ANALYSIS OF SAMPLES OF RECEIVED  
REFILLABLE REFRIGERANT GAS  
CYLINDERS

Made in China

## SAMPLE 1

Photos from the cylinder received.

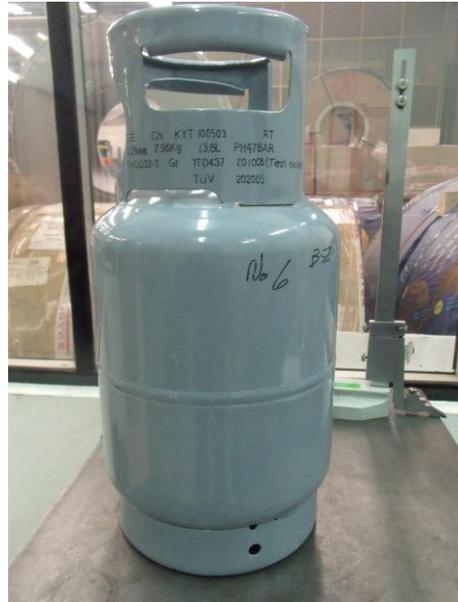
2.2. The format of the initial test date (201005) is wrong and not in compliance with 6.2.2.7.1 of ADR (the year and month need to be separated by a slash and should be indicated as: 2010/05);

2.3. The Notified Body number identification stamped is 0437 (MIRTEC-Greece) but another “TÜV” indication was made on the collar (see picture 1) of which the purpose is not clear. It seems that the manufacturer has already stamped the

markings for the periodic inspection and test at the stage of manufacture, namely the markings according to ADR 6.2.2.7.6 – the inspection body’s mark and re-test date (see picture 4: TÜV 202005). This is wrong and totally misleading, because these markings must be applied at the time when periodic inspection is carried out;

### 1.3 Paint Thickness( $\mu$ )

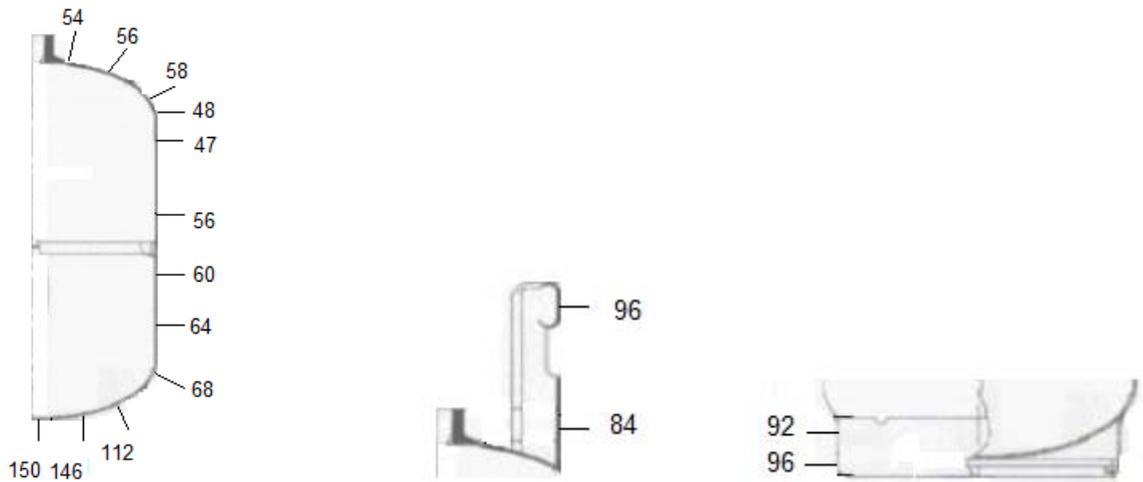
2.1. The minimum wall thickness is indicated on the collar with 2.29 mm (see picture 1) however the values found (see 1.2) fail to meet the minimum requirements on several measured points of the cylinder body;
